**Independent Advisory Panel to IDB Invest**  
**IAP Report N°4, June 2020**  
**Ituango Hydropower Project**  
**Colombia**

*Dam Engineering and Safety (Chair)*

Figure 5 Exploration campaign South zone. Shafts 5 to 8

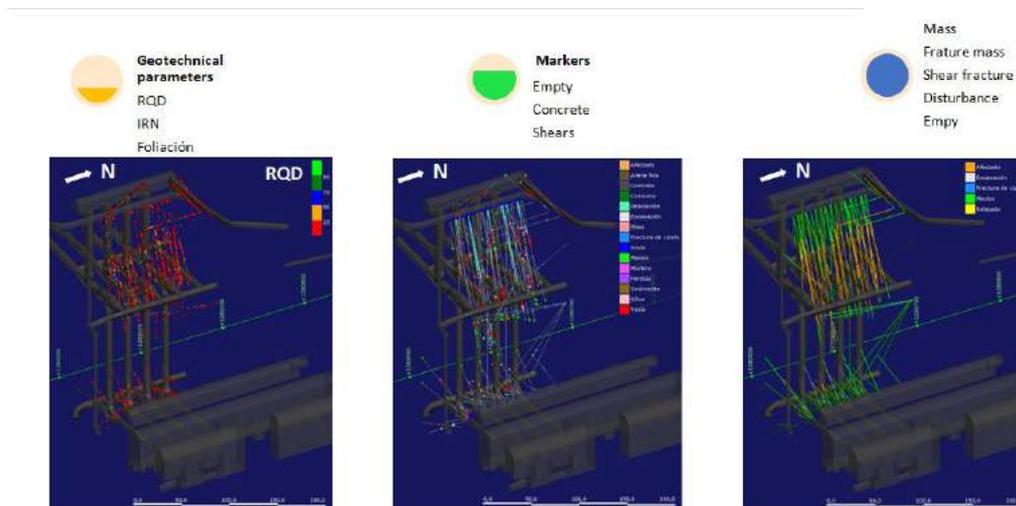
An extensive campaign of boreholes and grouting has been carried out in the area (see Fig. 5). From the information provided, the IAP is not sure that voids exist in the upper part of the shafts. In the lower part of the shafts, voids are reported to exist, but the examined borehole data do not permit to confirm that. In any case, the information collected should be adequate for a detailed characterization of the rock mass.

The IAP recommends preparing a zoned classification of the rock mass, giving due consideration to the reliability of the cores. The GSI method could be used for that purpose. The design of rehabilitation works should be based on actual rock mass defects (open joints, shear zones, loose rock, cavities etc.) and associated potential mechanisms of failure.

Figure 7. Multi-Point Borehole Extensometer reading, where some displacement reached 5mm.

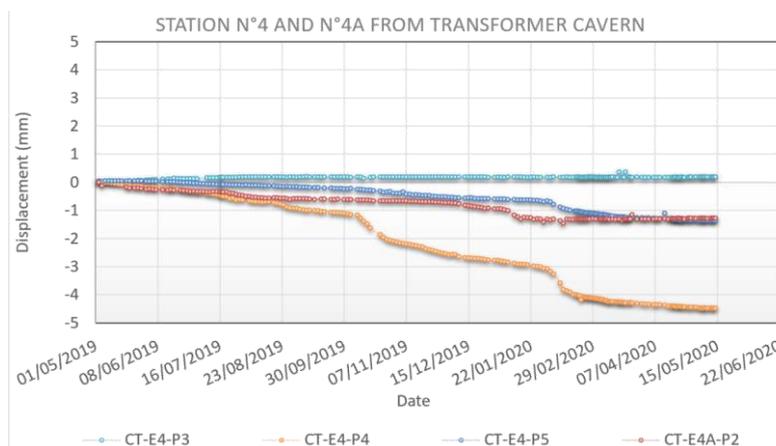
In few places slight deformations have been recorded. Reportedly, the largest displacements (5mm) have been recorded at specific locations where major interventions took place. That is evident from the orange line in fig. 7.

Such movements, albeit small, go beyond the level of instrument's accuracy, therefore an increased monitoring frequency should be adopted in case those displacements would not show sign of stabilization. Obviously, monitoring should continue everywhere.

Fig 10 Drainage to massive concrete reconstruction of Almenara 1.

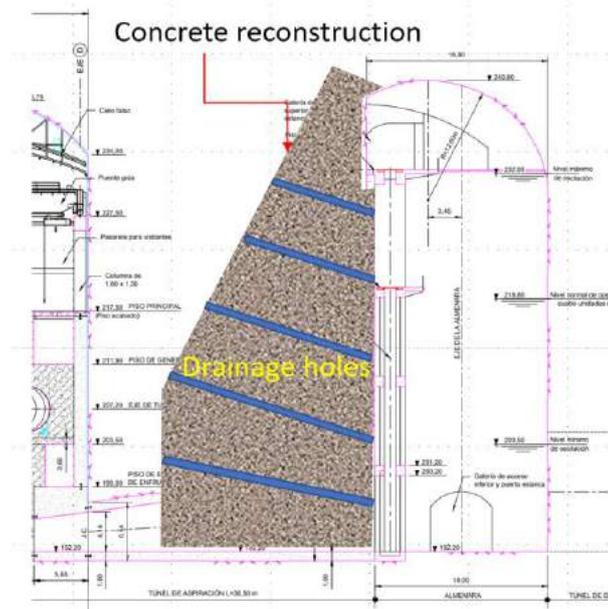
The rehabilitation design foresees reconstructing the Almenaras with concrete backfills, after rock mass reinforcement. The backfill will be particularly massive in the case of Almenara 1 and the build-up of water pressures could be destabilizing, especially in consideration of the oscillations in the surge chamber. The IAP recommends that the Designer assesses the need of drainage holes: Fig 10 shows a notional layout.

Figure 16: Power intakes- Localized cracks in the upper part of the slopes

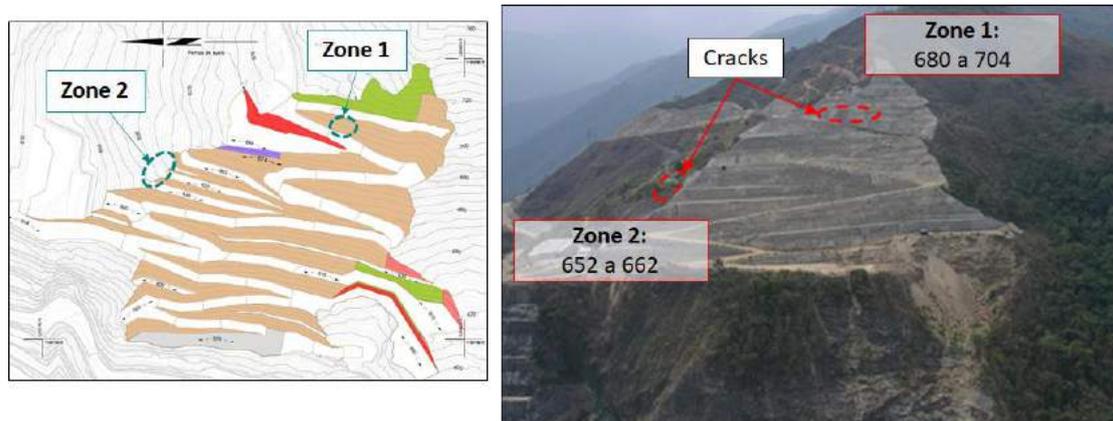
Some cracks have appeared on the upper parts of the slope. Of these, the cracks in Zone 1 do not necessarily agree with the results of stability calculations and may need to be reconsidered in modelling the slope (e.g. tension cracks).

The other cracks are generally localised fissures in the shotcrete, which are most probably associated with slight changes of rock mass weathering, boundaries/ discontinuity of shotcrete treatment and consequent differential movements. Drainage holes in shotcrete are obviously an appropriate measure and probably will have to be increased in number.

Figure 17: Drainage gallery – Piezometers. Site 7

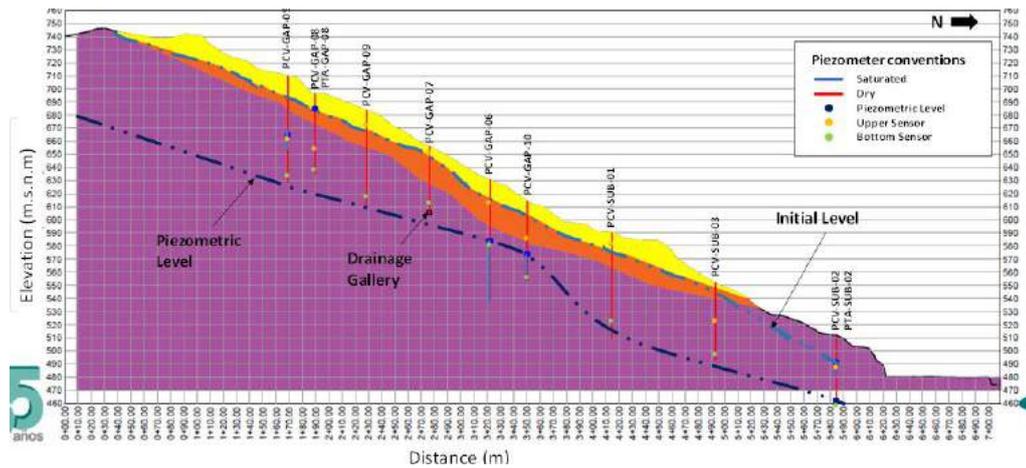
The effectiveness of the executed drainage gallery at the northern slope side is not clear to the IAP. Apparently, it is in relation to Site 7 slopes, at the North margin of Romerito's treatments. Besides, the gallery is located above the assessed water table. The perched water table, above, looks insignificant. Anyway, drainage is always useful in slope stability and the IAP has no specific recommendations.

Figure 18: Inclinometer readings in the slope over the platform of gates. The curves do not evidence any deformation or rupture of the inclinometer tube.

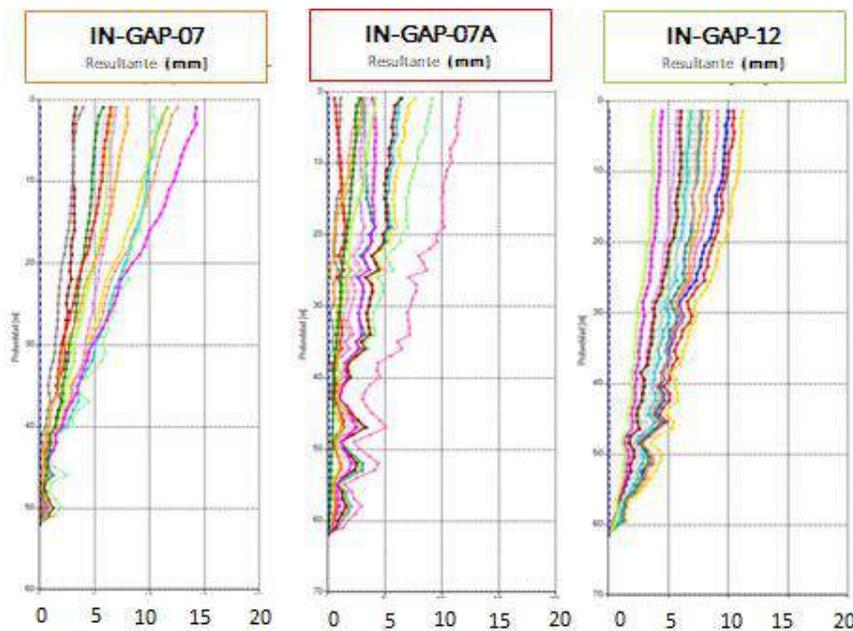
Inclinometer measurements in the area, indicate a pattern of displacements (fig. 18) that does not correspond to a recognizable sliding surface at any level. No abrupt changes of slope are visible along the inclinometer alignments. Most probably, the recorded movements result from incomplete or defective fitting of the inclinometer's tube in the drill holes.

*Figure 19: The destabilized area above the two diversion tunnels. In the far upper end the slopes of Romerito, before the reshaping and treatment*

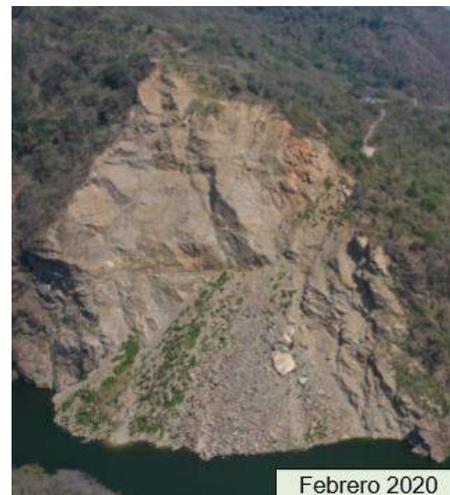
The issue has been raised in all IAP reports. A slope in those conditions cannot be left behind untreated. It is too close to the dam, and we cannot preclude the possibility of completing the IDG or even adding an MLO during the life of the Project.

Figure 36: Ituango Turbine Hill Chart

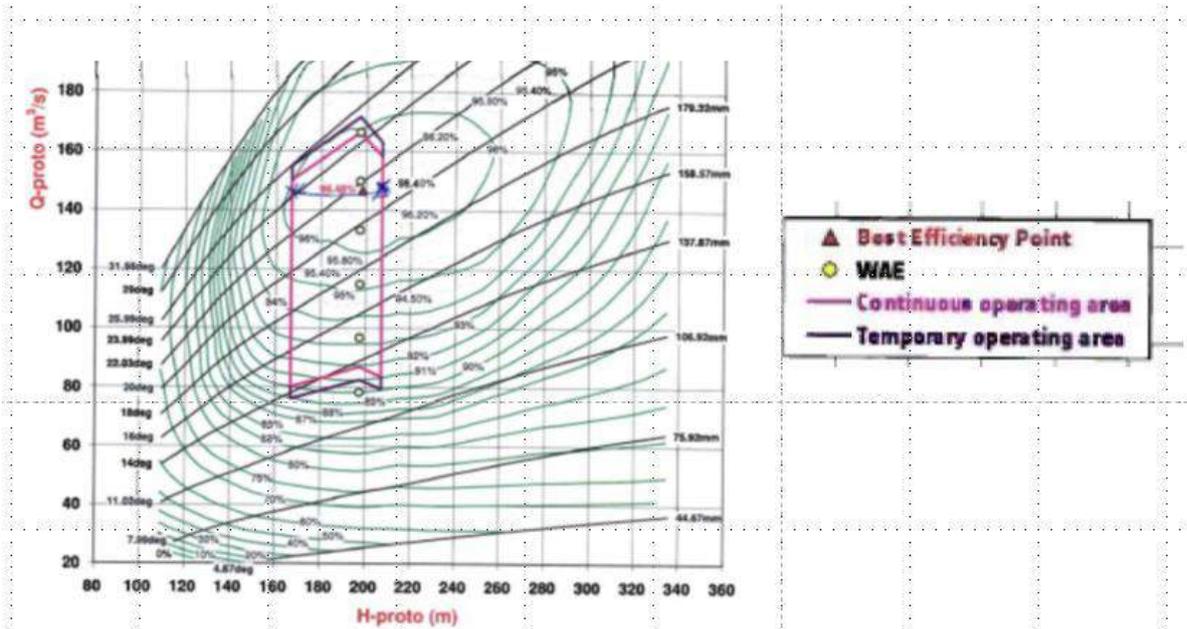
Fig. 36 shows Ituango’s turbine “hill-chart”. The “Continuous Operating area” appears the result of EPM’s request for an area of very high efficiency rather than a physical limitation. The ratio Gross Maximum Operating Head / Gross Minimum Operating Head based on reservoir level is approximately 85% and the ratio Minimum Head / Maximum Head of the prototype as per Model Test is 80%. Both numbers are on the low side.

Moreover, it should be noted that the operation of the turbine below its official minimum head would still fall in an area of high efficiency (above 90-91%), especially for high values of Q (the ones more interesting). That indicates respectable turbine performance.

Fig. 38: Probabilities of failure put in context

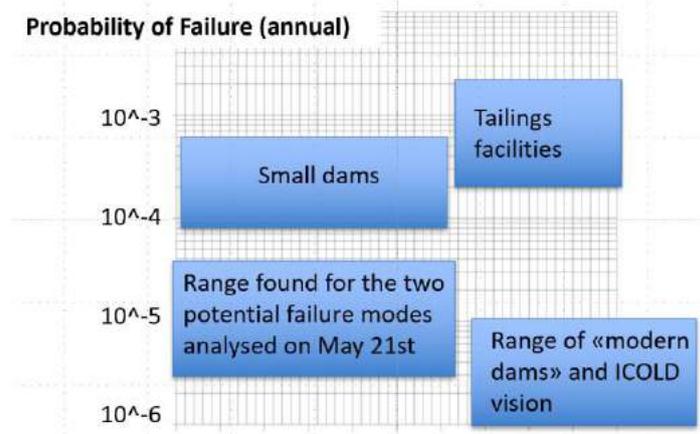
The PF obtained, for the two PFM analysed on May 21<sup>st</sup>, range from  $5 \cdot 10^{-5}$  (maximum) to  $3 \cdot 10^{-6}$  (minimum). To put such values in perspective, it should be noted that the PF of modern dams is generally considered to be around  $10^{-5}$ <sup>3</sup>, and that the ICOLD “vision” and commitment is to further reduce that PF to  $10^{-6}$ . Figure 38 puts the above values in perspective (indicative ranges for small dams<sup>4</sup> and tailings facilities<sup>5</sup> are shown for comparison). *If one reverses the figure, i.e. Safety Margin =  $1/PF$ , the picture may become more familiar for those not acquainted with probabilities.*

It is desirable, for a project of the importance and hazard level such as Ituango, to aim at the “ICOLD range”. Two key measures can achieve that result:
